DATE	02/07/96	CESSNA AIRCRAFT COMPANY
DRAWN	ROBERT SCOTT	AIRCRAFT DIVISION
GROUP		P.O. BOX 7704
CHECK		WICHITA, KANSAS 67277
SECT		
PRD J		
M. E.		
OTHER		
FABRICATE PER CES260A		SIZE F50N NO.
PROCESS PER XXXXXXXXXXXXX		DWG NO.
WIRE TERMINATION PER CES271E		F 71379
SCALE:		SHEET 1 OF 1

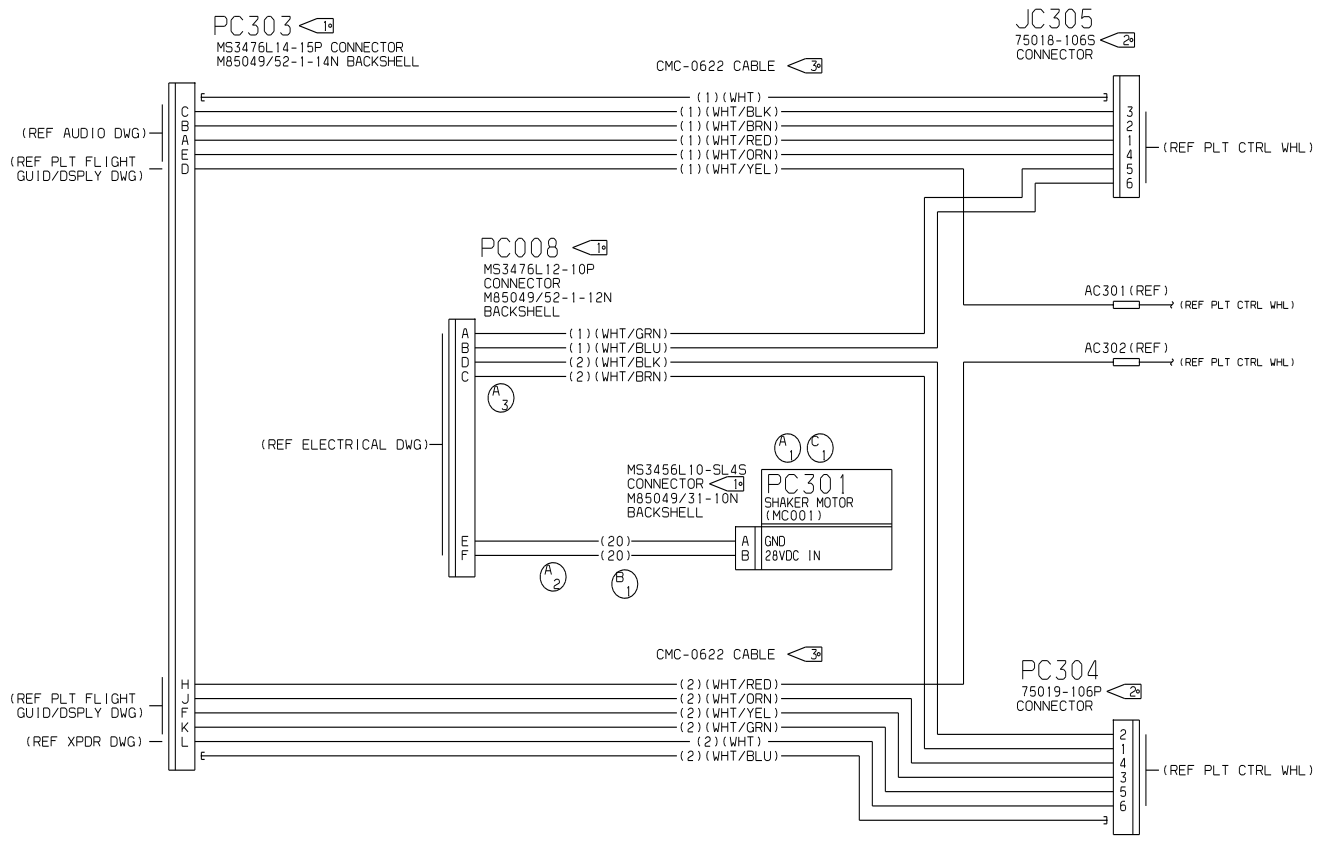
REVISIONS			
SHEET	REV	DESCRIPTION	DATE APPROVED
	A	BY REVISION: 1) ADDED CONNECTOR PC019 2) ADDED WIRE: EPC008-APC019 AND FPC008-BPC019 3) REF PC008: PIN C WAS PIN D PIN D WAS PIN C EFF: EC 34158 WO XL-0538	07/17/96 SEA
	B	BY REVISION: 1) CHANGED WIRES EPC008-APC019 AND FPC008-BPC019 FROM 22 GA. TO 20 GA. CHANGES MADE TO ANSWER PROB WORKSHEET P151-0285 EFF: EC 34158 WO XL-0905	11/21/96 SAS
	C	BY REVISION: 1) CHANGED REF DES: WAS PC019 2) ID TAG P/N WAS CM2987-1 EFF: EC 34158 WO XL-1114	02/12/97 SEA
